## **Preliminary Site Plan and Special Land Use Review Dexter Township, Michigan**

<b>Applicant:</b>	Corn Man LLC
<b>Project Name:</b>	Cornman Farms Building Additions
<b>Plan Date:</b>	October 31, 2023
<b>Location:</b>	8540 Island Lake Road (D-04-36-400-002)
<b>Zoning:</b>	RR, Rural Residential
<b>Action Requested:</b>	Preliminary Site Plan and Special Land Use Approval
<b>Required Information:</b>	Deficiencies are noted in the sections below.

This is our first review of the preliminary site plan for additional buildings to the Cornman Farms special event facility. The event facility is located on three (3) parcels: D-04-36-400-002 located in Dexter Township, and C-03-31-300-003 and C-31-300-011 located in Webster Township. No improvements are proposed on the Webster Township parcels. For the purposes of this review, the subject site refers to the parcel in Dexter Township, D-04-36-400-002.

FLOOR PLAN - SECOND FLOOR &  
BASEMENT

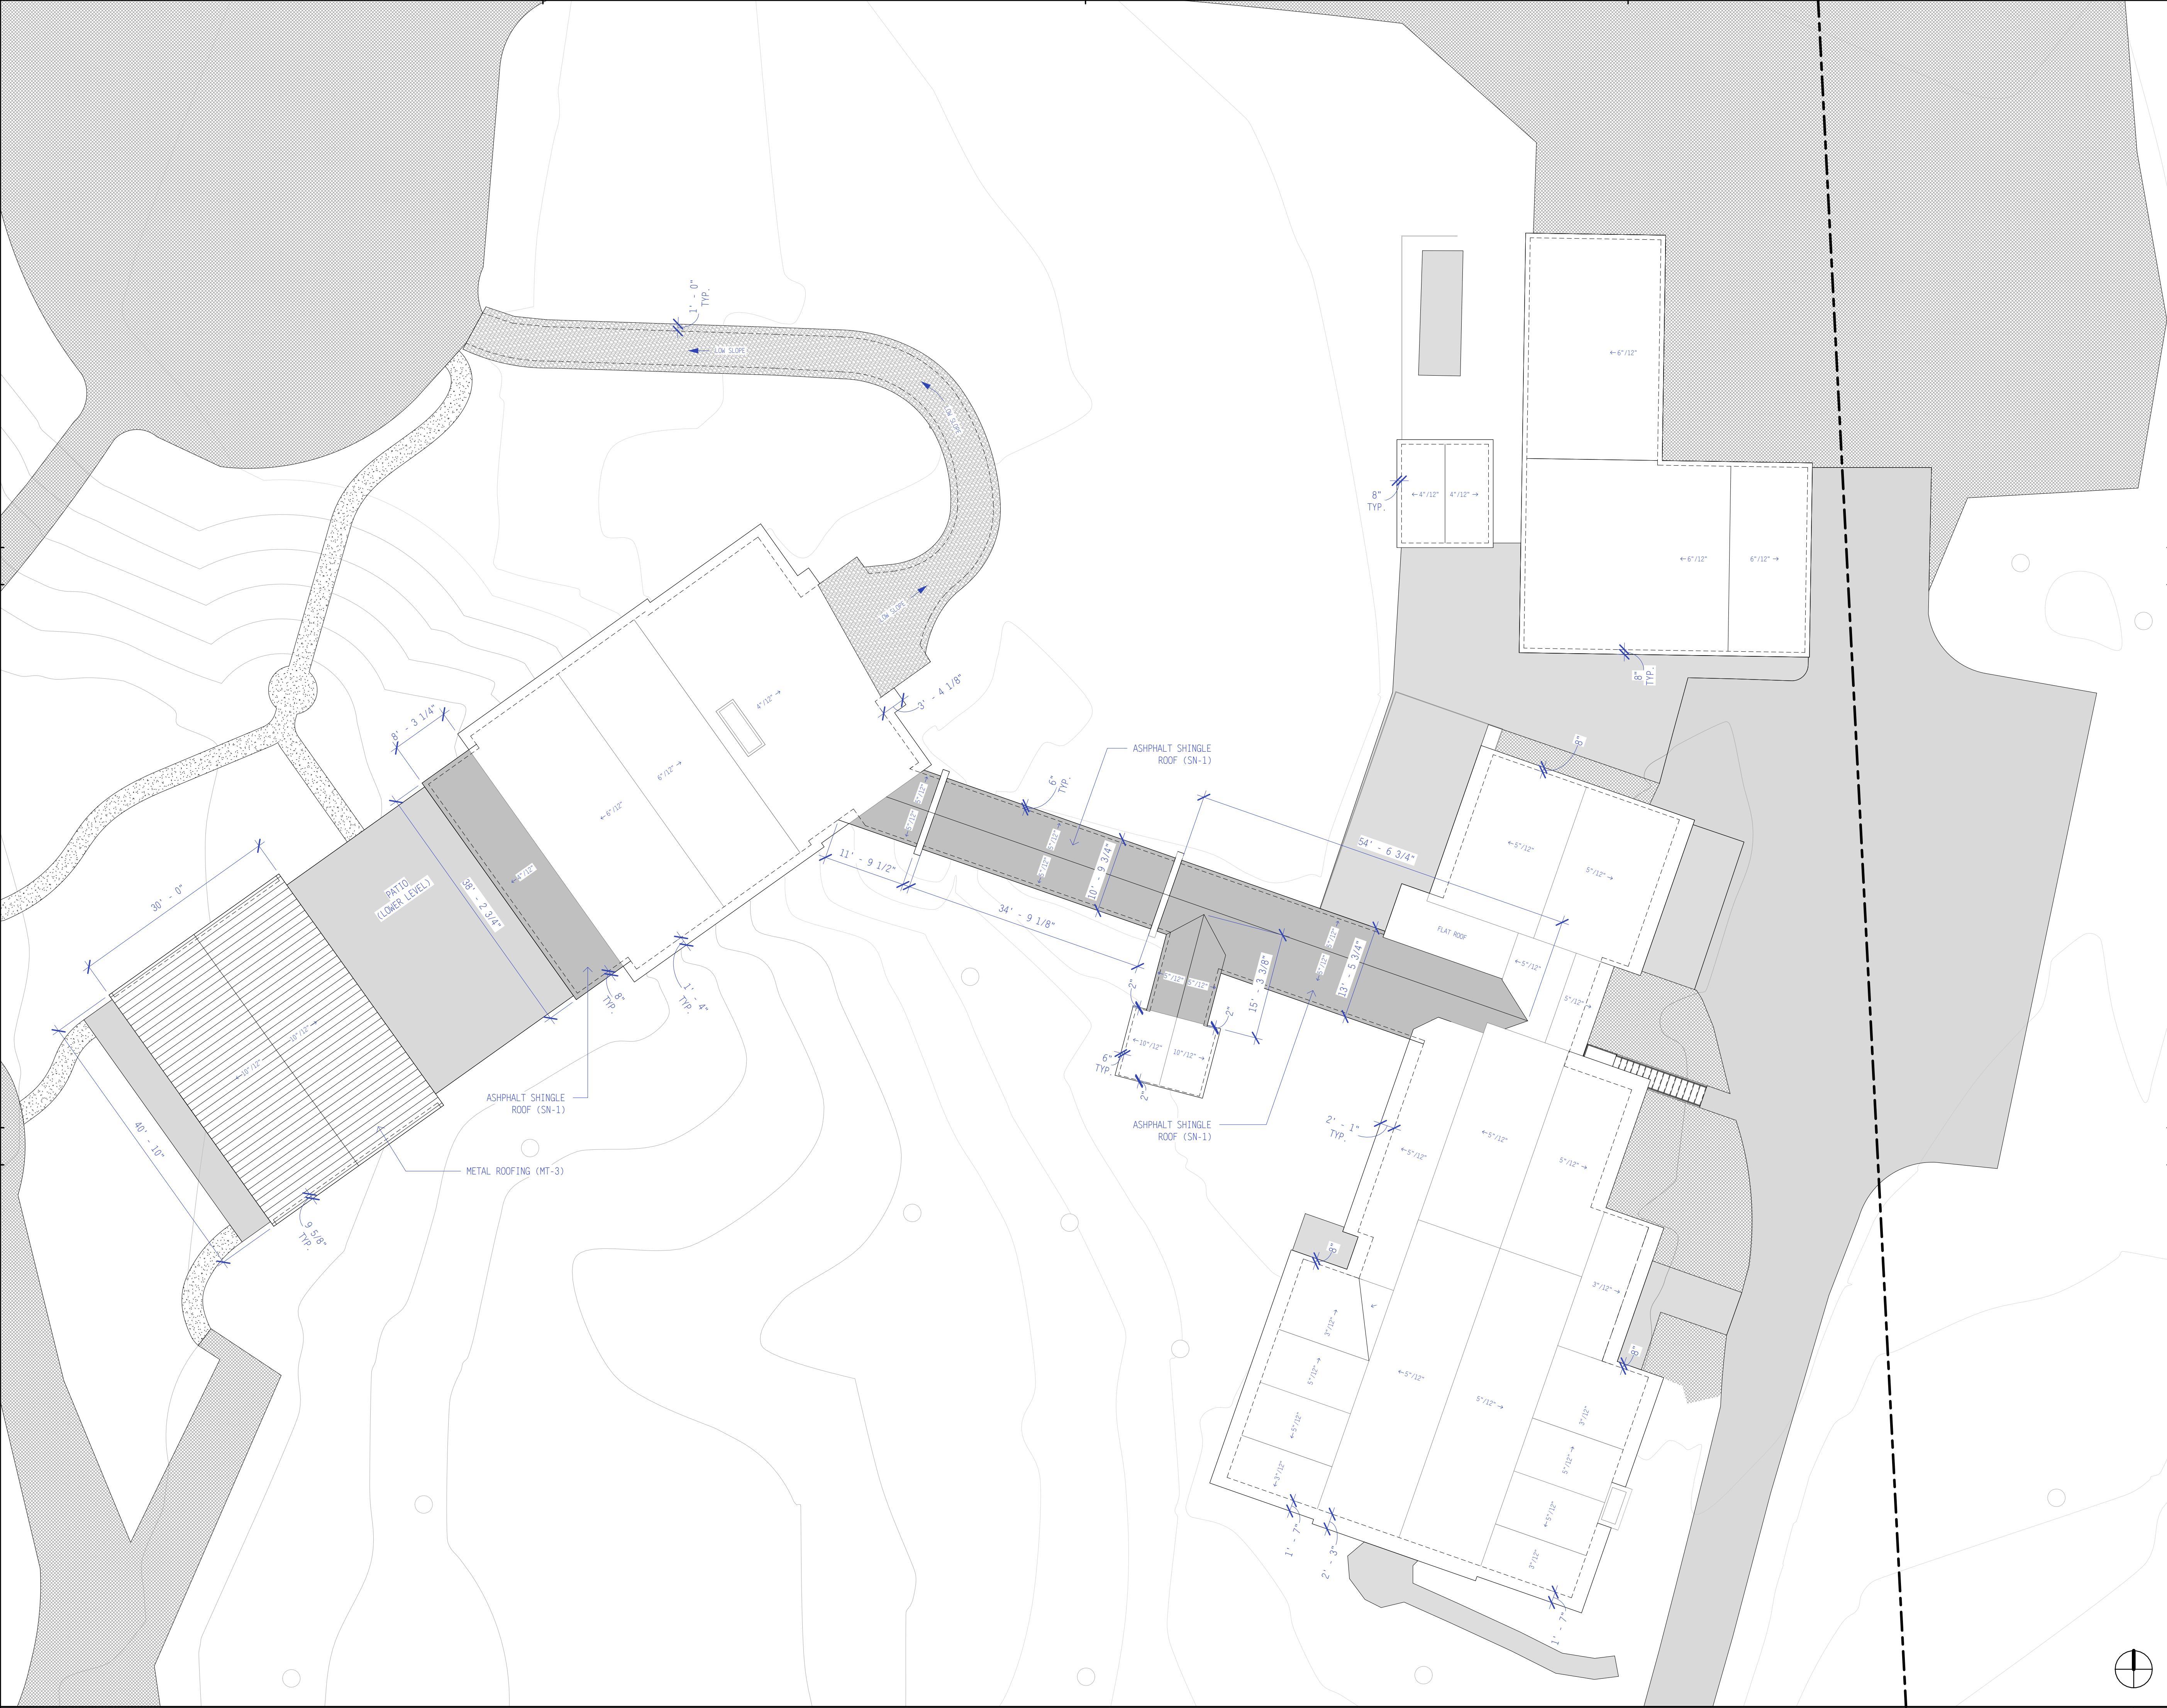
We note that the floor plans on Sheets A-1.00 and A-1.01 show seating in the pavilion and red barn for eighty (80) guests. The applicant should increase the maximum number or revise the floor plans.

**Items to be Addressed:** Clarification from applicant on maximum number of guests.
